ECE/TRANS/WP.29/GRE/2006/51
21 July 2006

PROPOSAL FOR DRAFT 03 SERIES OF AMENDMENTS TO REGULATION No. 10

(Electromagnetic compatibility)

Submitted by the expert from the European Commission (EC)

Appendix 2

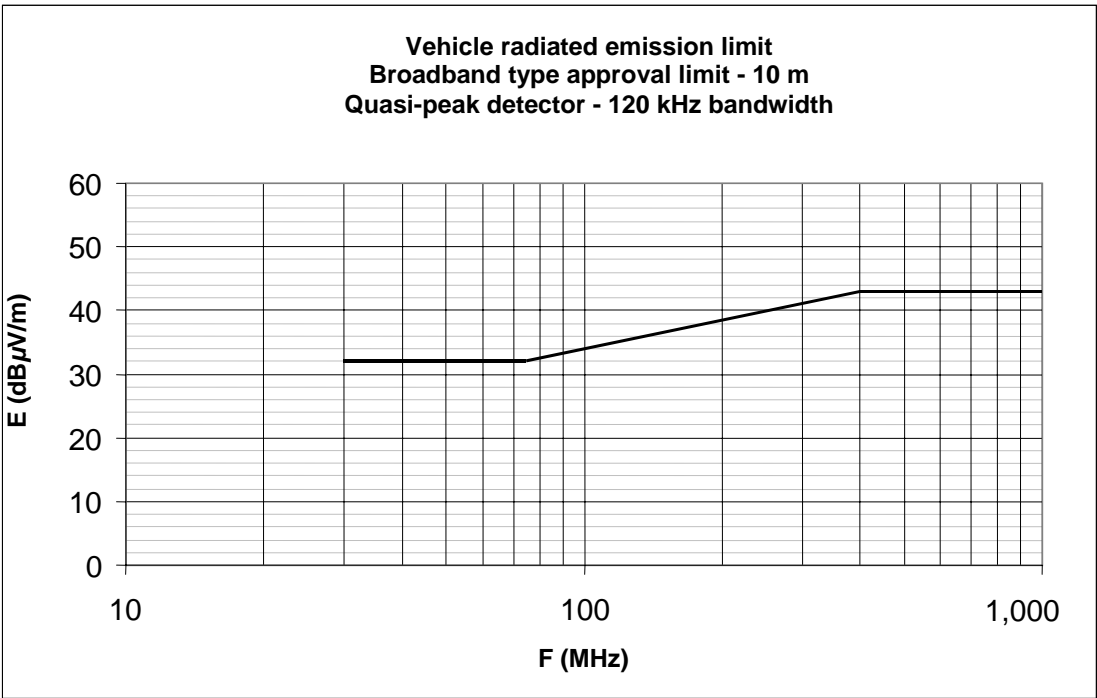
Appendices 1 to 6, amend to read:

Antenna-vehicle separation : **10 m**

Limit E (dBµV/m) at frequency F (MHz)		
30 - 75 MHz	75 - 400 MHz	400 – 1,000 MHz
E = 32	$E = 32 + 15.13 \log (F/75)$	E = 43

"Appendix 7

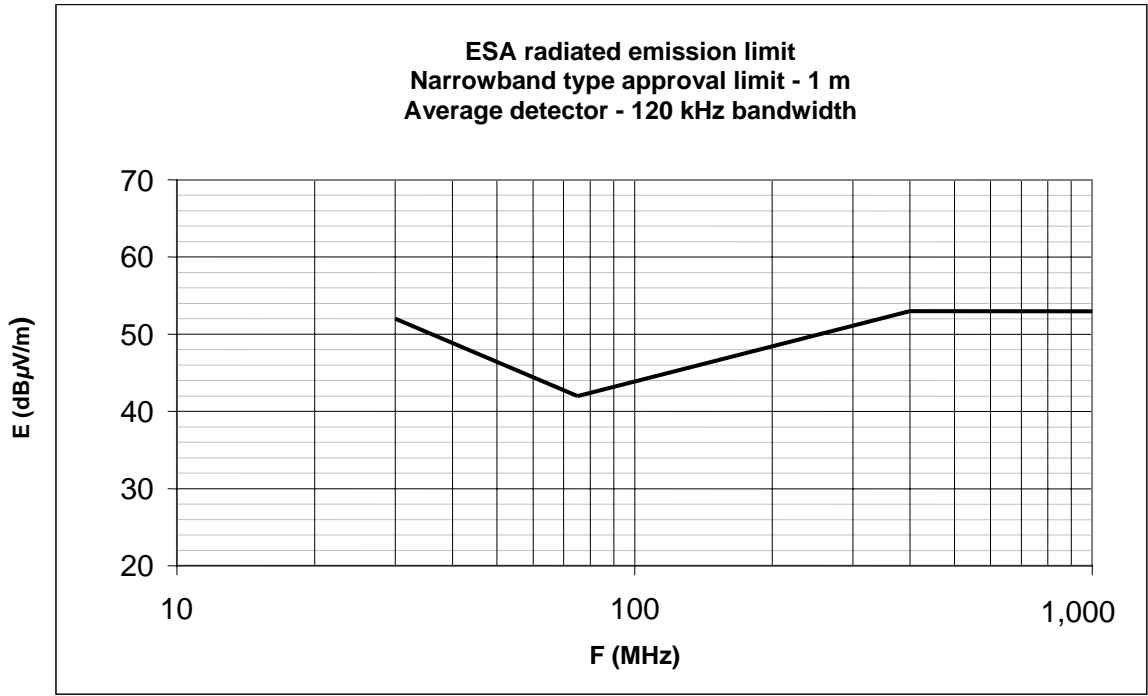
Insert a new Appendix 7, to read:

Limit E (dBµV/m) at frequency F (MHz)		
30 - 75 MHz	75 - 400 MHz	400 – 1,000 MHz
$E = 52 - 25.13 \log (F/30)$	$E = 42 + 15.13 \log (F/75)$	$E = 53$

Figure 1

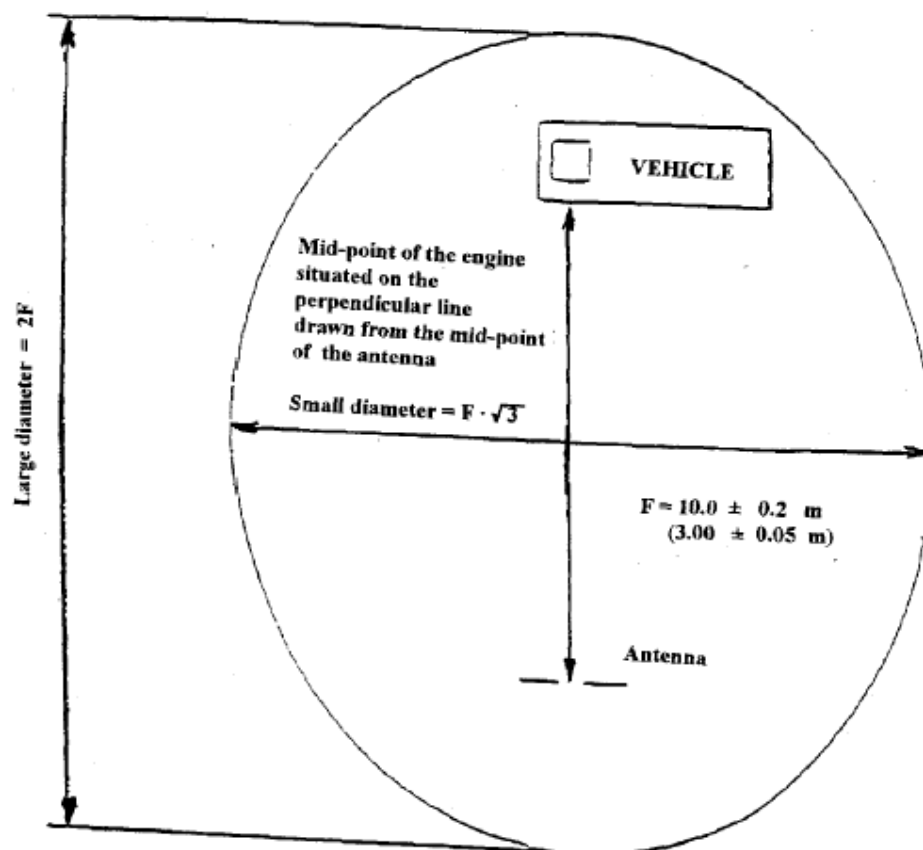
3.1 As an alternative to the requirements of CISPR 12 (amendment 1, fifth edition 2005) for vehicles of category L the test surface may be any location that fulfils the conditions shown in the figure 1 in the appendix to this annex. In this case the measuring equipment must lie outside the part shown in the figures 1 and 2 of Appendix 1 to this annex.

Clear horizontal surface free of electromagnetic reflection
delimitation of the surface defined by an **ellipse**
